**Planned Unit Development Site Plan – Lots 1-3
Southport West – Southport West 32, LLC**

**Preliminary Plat - Southport West Replat 10 –
Southport West 32, LLC**

**CITY OF LA VISTA
PLANNING DIVISION
RECOMMENDATION REPORT**

CASE NUMBERS: PSPP25-0001;
PPUD25-0002

Figure 4

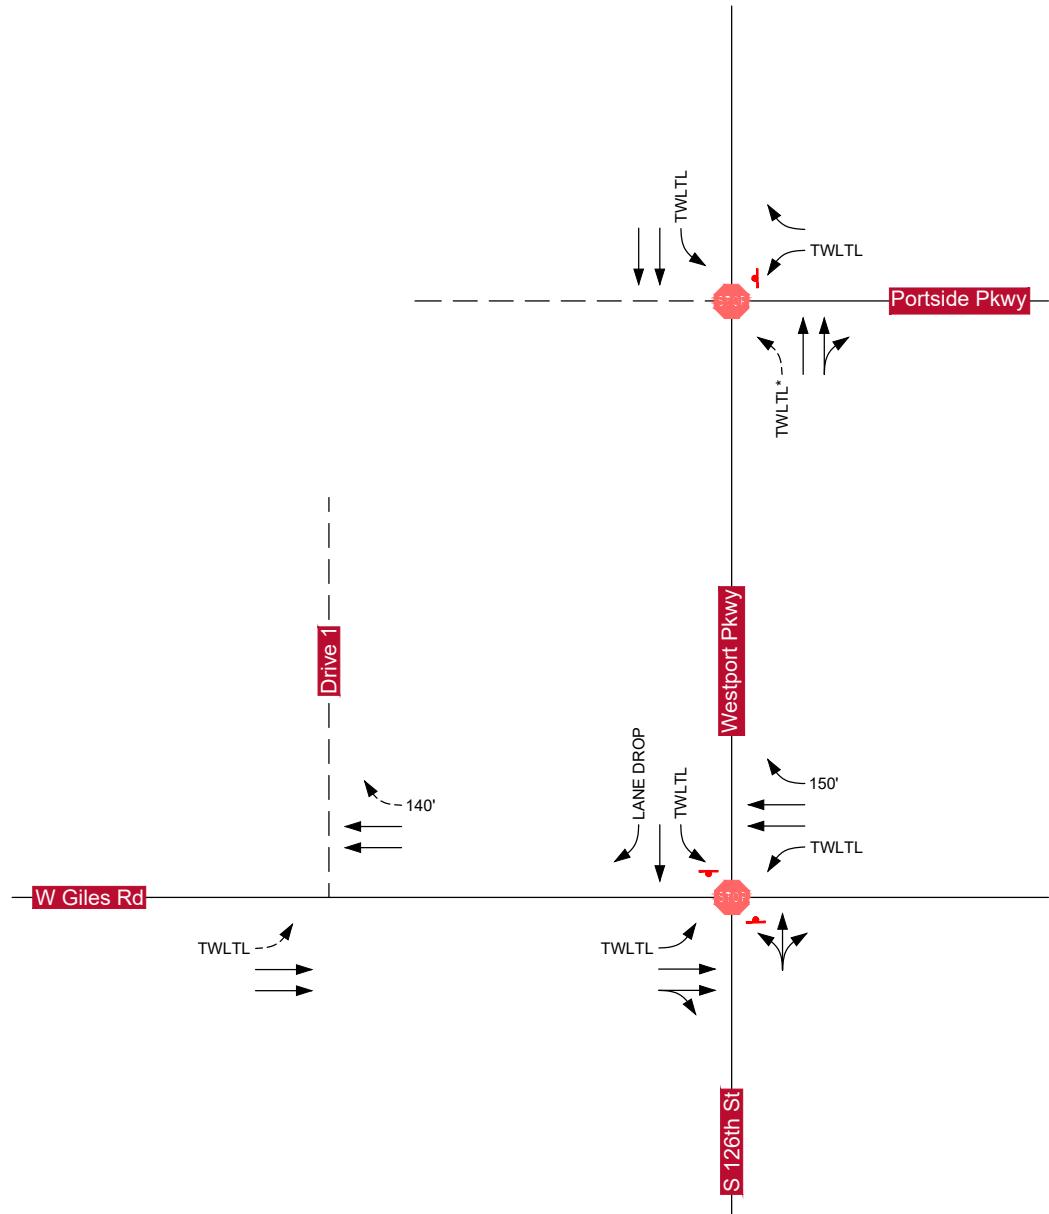
1. Existing Section, Page 1, Figure 4: Several of the stop-controlled northbound and southbound movements at the intersection of 126th Street/Westport Parkway with West Giles Road currently operate at LOS E or F during the study peak hours. LOS E or F operations are not uncommon for stop-controlled side street movements during peak hours.

1. Existing Section, Page 1, Figure 4: Several of the stop-controlled northbound and southbound movements at the intersection of 126th Street/Westport Parkway with West Giles Road currently operate at LOS E or F during the study peak hours. LOS E or F operations are not uncommon for stop-controlled side street movements during peak hours.

Figure 9

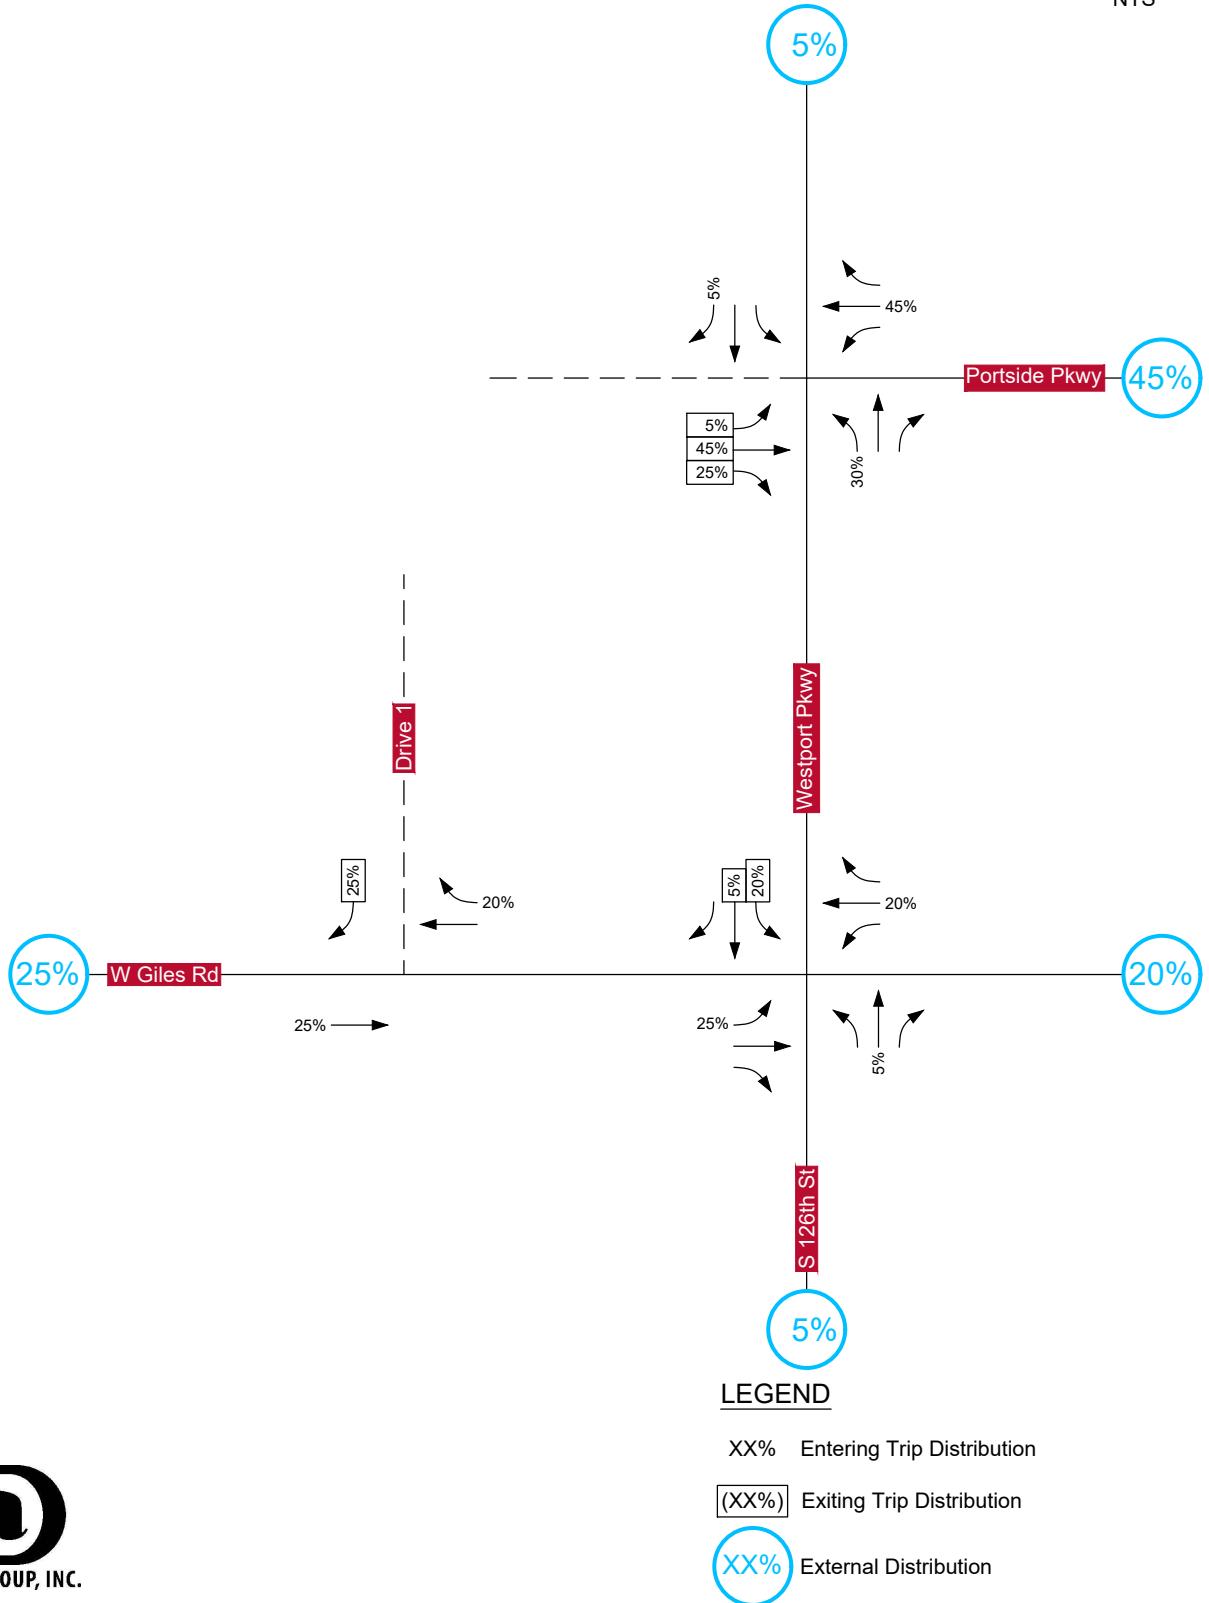
4. Site Section, Page 2, Figure 9: The memo refers to the ITE Trip Generation Manual 11th Edition and provides expected site trip generation volumes for daily and peak hour time periods.

4. Site Section, Page 2, Figure 9: The memo refers to the ITE Trip Generation Manual 11th Edition and provides expected site trip generation volumes for daily and peak hour time periods.
